Access Compliance Report Public Rights-of-Way (Curb Ramps)

Main Street: PALM_AVE Cross Street: YORBA_LINDA_BLVD_004 Location: NE

ADA ID: RPAT220221101506 Ramp Type: Type 1 - Perpendicular Initial Pass/Fail: Fail Overall Compliance: No Severity Score: 2

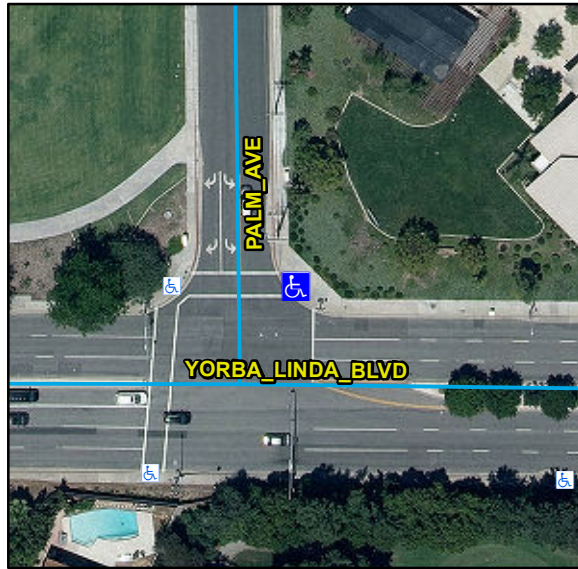
Compliance	Description	Data	Compliance	Description	Data
N/A	Ramp Length (in)	112	N/A	Flare Type LT	
Yes	Ramp Width (in)	48			N/A
Yes	Ramp Run Slope (%)	4.8	N/A	Flare Slope LT (%)	N/A
No	Ramp Cross Slope (%)	2.9	N/A	Flare Traversable LT	N/A
N/A	Landing Present	N/A	N/A	Flare Type RT	
N/A	Landing Length (in)	N/A			N/A
N/A	Landing Width (in)	N/A	N/A	Flare Slope RT (%)	N/A
N/A	Landing Run Slope (%)	N/A	N/A	Flare Traversable RT	N/A
N/A	Landing Cross Slope (%)	N/A	N/A	DWS Provided	N/A
N/A	Landing Movement Obstructed?	N/A	N/A	DWS Contrast	N/A
	Landing Movement Type	N/A	N/A	DWS Length (in)	N/A
N/A	Landing Shared	N/A	N/A	DWS Full Width	N/A
N/A	Clear Space	N/A	N/A	DWS Offset Left (in)	N/A
N/A	Clear Space To Crosswalk (in)	N/A	N/A	DWS Offset Right (in)	N/A
N/A	Marked Crosswalk 1	Yes	N/A	Marked Crosswalk 2	N/A
	Crossing 1 Direction	W		Crossing 2 Direction	N/A
	Marked Crosswalk 1 Width (in)	144		Marked Crosswalk 2 Width (in)	N/A

Remove & Replace Entire Ramp.

R304.5.3, STD 1115
